Cycle Enfield - Section 5

A105 Green Lanes junction with Bourne Hill / Hedge Lane

Stage 2 Road Safety Audit

Ref: 2759.03.05/032/A105/BOR/2016

Problem Locations

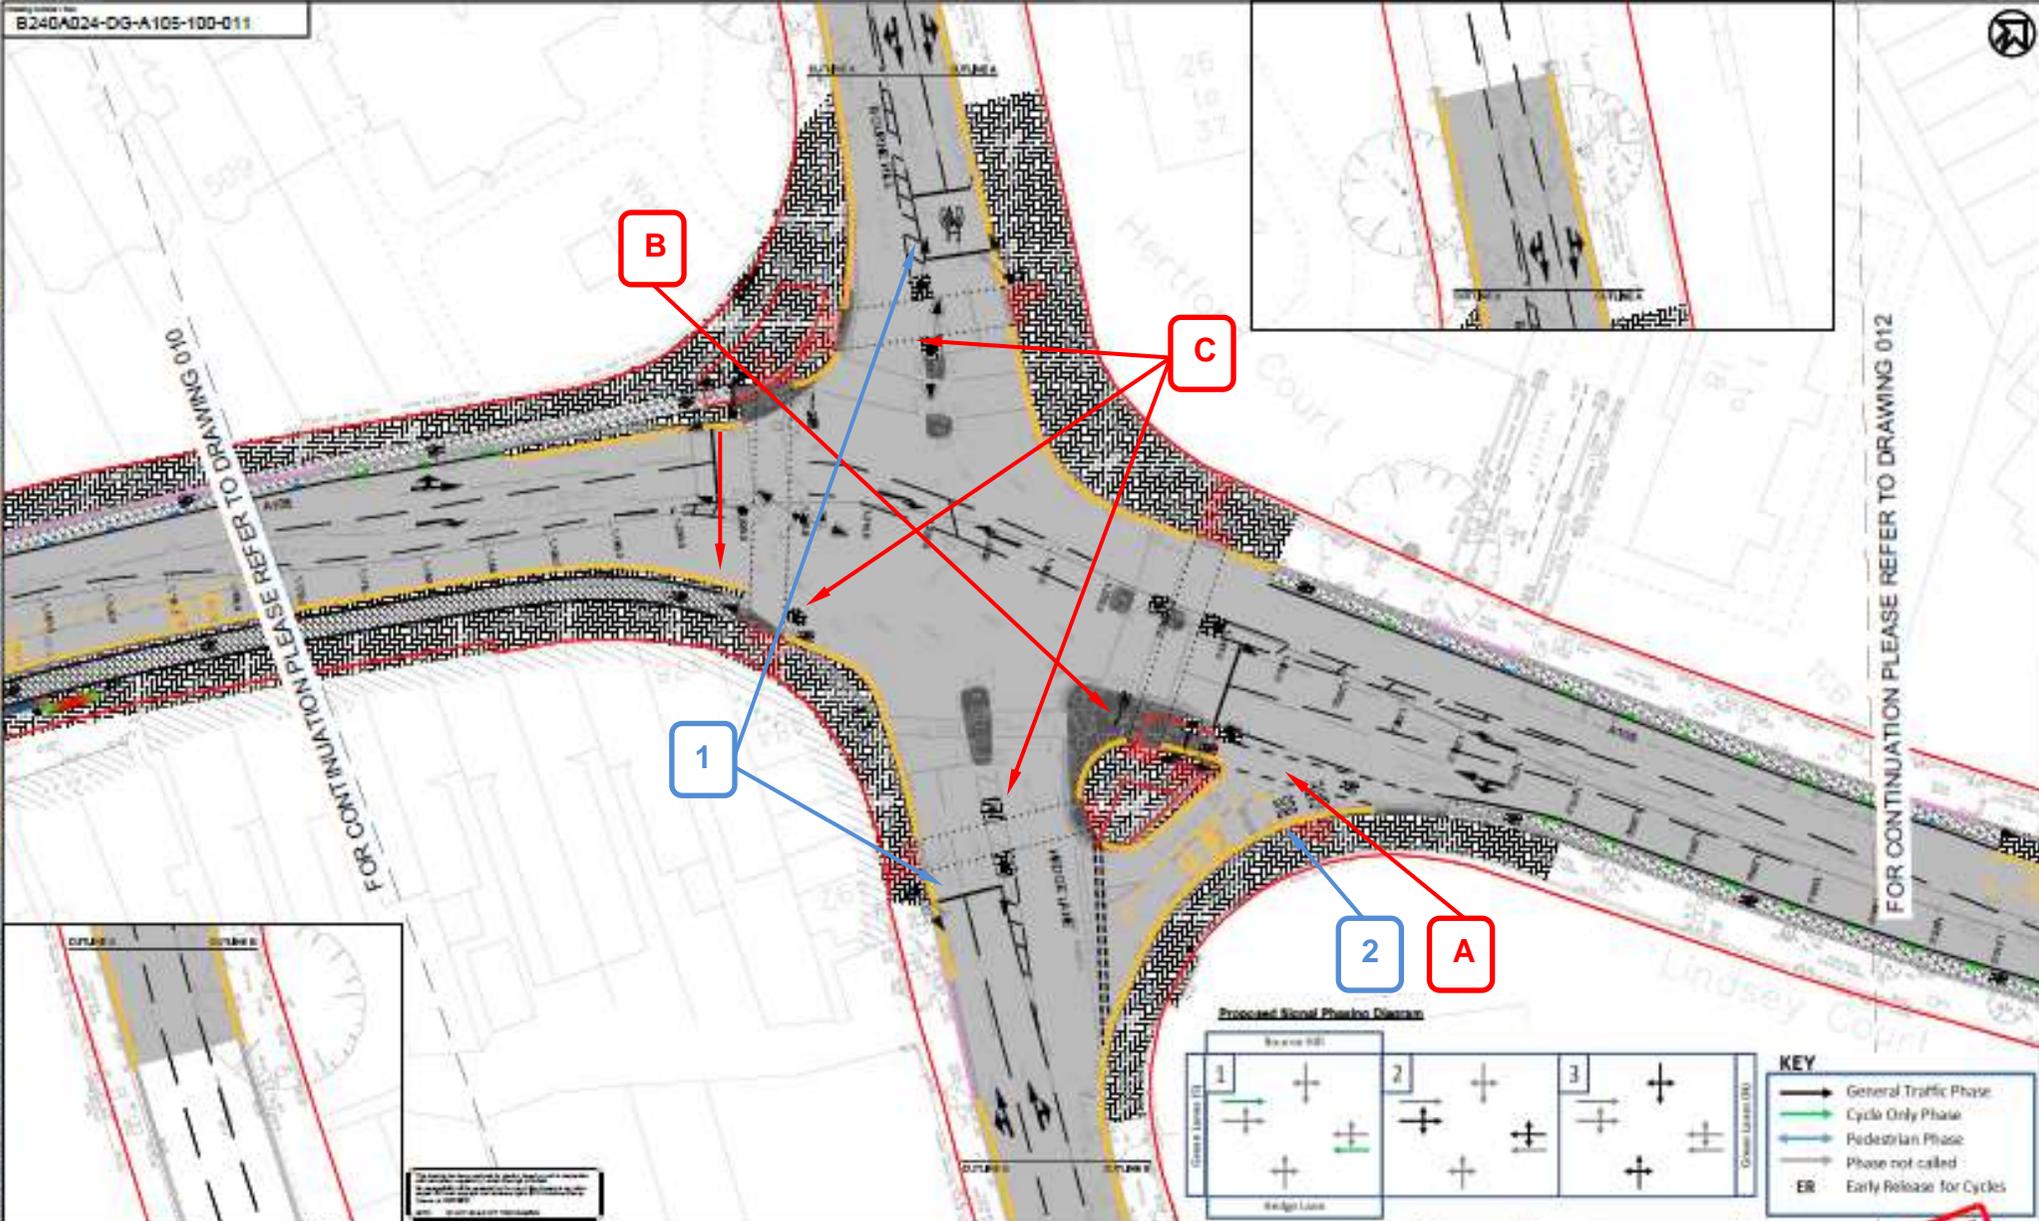
The proposed layout results in the semi segregated cycle lane returning to the carriageway just before the left turn slip for motorists to turn left from Green Lanes on to Hedge Lane. The proposed road markings indicate this is a bus gate but no other corresponding signs or road markings clarify this and it is therefore anticipated that some general traffic will also use this area. It may be difficult for both sets of road users to understand who has priority and this may lead to left hook type collisions as motorists potentially turn across the path of cyclists attempting to continue ahead.

The signalised junction ahead also results in an increased potential for cyclists to be travelling faster than vehicles whom may be queuing in traffic. Left turning drivers may struggle to see or anticipate a cyclist undertaking on the nearside, which may exacerbate the potential for left hook type collisions.

If the left turn slip is intended to be used by buses only then this should be made more conspicuous with additional signs and road markings. It may be beneficial to clarify priorities between cyclists on the track and left turning vehicles. As the current gap that cyclists have to cross is long it may be beneficial to alter the layout to reduce the distance over which they are exposed to turning movements which may also have the added benefit of reducing vehicle speeds and potentially making this less appealing for general traffic. This would require careful consideration of the movements which buses undertake and the implications on swept paths of vehicles.

The proposed layout includes two stage right turns (2SRT) from Bourne Hill and Hedge Lane. The Audit Team are concerned that the road markings alone may not clearly convey the intended manoeuvre and that once at the intended waiting position before making the second stage of the right turn cyclists may not be able to clearly see a relevant traffic signal. This is particularly relevant for users trying to travel southbound (from Bourne Hill) as the lack of secondary traffic signal may make it difficult for them to know when it is safe to proceed. If cyclists attempt to proceed at the wrong time they may face an increased potential for collisions with passing vehicles.

It is recommended to provide signs to clearly indicate the intended manoeuvres for cyclists and also to ensure that a relevant traffic signal is clearly visible to encourage cyclists to set off at the most appropriate time.

The proposals include various kerb line alterations which may increase the potential for turning vehicles to encroach into another user's path or collide with a kerbed island. This could lead to an increased potential for head on, side impact type collisions or collisions with physical islands / revised kerb lines.

It is recommended to undertake / check swept path analysis and make alterations if necessary to ensure that the vehicles likely to use these roads can undertake typical manoeuvres with minimal intrusion into the path of another vehicle or over-running / scrubbing of kerbs.

The proposals include an Advanced Stop Line and a two stage right turn (2SRT) for for cyclists exiting Bourne Hill but only a two stage right turn for cyclists exiting Hedge Lane.

The lack of an ASL for cyclists exiting Hedge Lane may make them more vulnerable to left hook type collisions, or for a driver of a HGV not to see them (in close proximity to the front of a HGV) as they pull away from the lights. This is not raised in section 3 as it is an existing issue but as cycling uptake may increase as a result of the overall scheme it may be beneficial to assess and if feasible include an ASL for cyclists on Hedge Lane.

The proposals include an uncontrolled crossing facility which crosses the rear end of a bus stand cage. It is possible that a visually impaired user utilising a tapping stick may identify the crossing point (tactile paving) and begin to cross and not identify the presence of the rear overhang of a bus.

It may therefore, be beneficial to relocate the bus stand further forwards so that it does not cover the crossing carpet.

The cycle lane is already at carriageway level on the approach to the junction and consequently motorists should be aware of cyclists travelling within the carriageway area, albeit within a semi segregated cycle lane.

It would not be possible to alter the layout of the left slip without compromising the ability of vehicles to bypass any buses parked in the bus stand.

Signage, markings and coloured surfacing should be considered to make clear that the slip road is for buses only.

Design Organisation Response	Accepted / Part Accepted / Rejected
The two stage right turn has been removed from this design as TfL signallers were not able to signalise it to the satisfaction of their Stage 2 safety auditor.	
Client Organisation Comments	
Operation of the junction to be reviewed post-implementation to assess whether 2SRT can be safely re-introduced.

Design Organisation Response	Accepted / Part Accepted / Rejected
Swept paths have been checked.	
Client Organisation Comments	
Designer's response accepted

Design Organisation Response	Accepted / Part Accepted / Rejected
The modelling shows that during the AM peak the DoS on all 4 arms is above 96% (PRC -9.5%). During the PM peak 3 out of 4 arms have a DoS equal or greater than 92% (PRC -9.1). It is possible to implement an ASL on the southern approach of the junction, however this would mean that the intergreens would increase and the already saturated performance of junction would be affected.	
Client Organisation Comments	
The impact of the addition of an ASL on Hedge Lane should be reviewed with the TfL and implemented if the impact on junction performance is minor.

Design Organisation Response	Accepted / Part Accepted / Rejected
The bus stand will be relocated further forward.	
Client Organisation Comments	
Designer's response accepted
